COMMENT LETTER – MALIBU CREEK AND LAGOON SEDIMENTATION AND BENTHIC EFFECTS TOTAL MAXIMUM DAILY LOAD

Comments of the County of Los Angeles and the Los Angeles County Flood Control District on Malibu Creek and Lagoon TMDL for Sedimentation and Nutrients to address Benthic Impairments

Figure: Jurisdictional Boundaries in Malibu Creek Watershed.

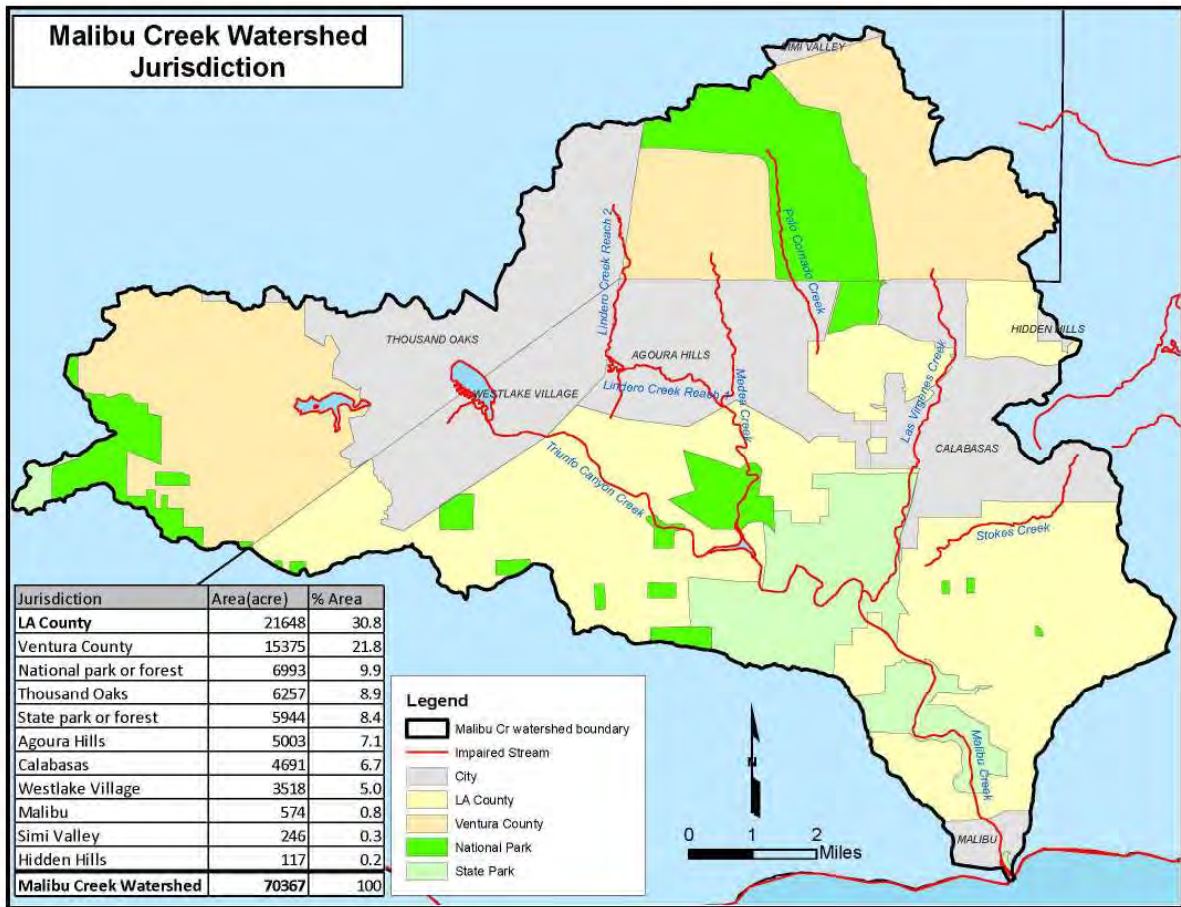
The California Department of Parks and Recreation has land management and ownership responsibility not only for the Malibu Lagoon but also for the State Parks in Santa Monica Mountains that drains to Malibu Creek. The land area under state jurisdiction accounts for about 8.5 percent of the Malibu Creek watershed. Additionally, about 10 percent of the watershed is under the jurisdiction of the National Forest Service. A map that shows the different jurisdictions within the watershed is attached.

Park and forest land management involve various activities including road or trail construction and maintenance, recreational activities, and timber management. As described in the “*Waiver of Waste Discharge Requirements for National Forest System Lands in California*”^[9], these activities are known to cause significant sediment and pollutant delivery to streams as well as removal of riparian vegetation resulting in water temperature and habitat changes. The County and cities have no control over the state and federal lands. Therefore, the impact of park and forest management activities on the Malibu Creek should be recognized in the TMDL, and the State and National Parks/Forest Services should be named responsible parties. Also, Figure 4-1 in the draft staff report should be revised to reflect the jurisdictional areas as indicated in the attached map.
